# **A D D E N D U M   N O .   2**

**ROOF REPLACEMENT AND RELATED WORK**  
**HILLSIDE INTERMEDIATE SCHOOL**  
Naugatuck, CT  
KBA #15037.00

Date: February 5, 2016  
Page: 1 of 1

TITLE: REVISED PARTIAL PCB ABATEMENT  
PLAN, RE: SHEET PCB-1

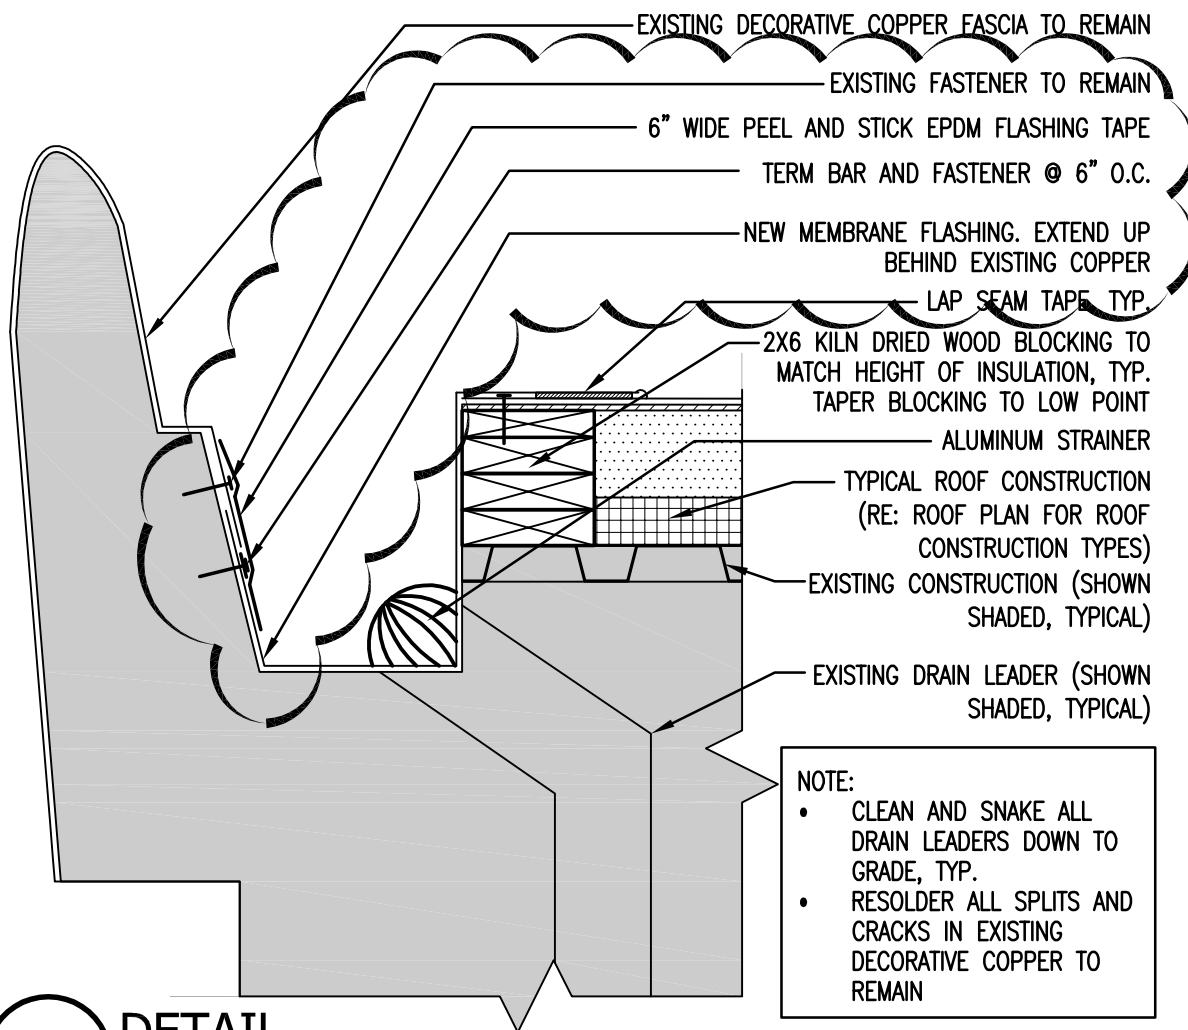
Area containing C-2 migration requiring remediation is confined to a section of 3 foot long and 3 inches wide strip of concrete as indicated in sketch SKA2.01.

**C2 CONCRETE REQUIRES REMEDIATION TO AN APPROXIMATE DISTANCE OF 3 INCHES FROM THE CAULK LINE. LENGTH OF AFFECTED CONCRETE IS APPROXIMATELY 3 FEET**
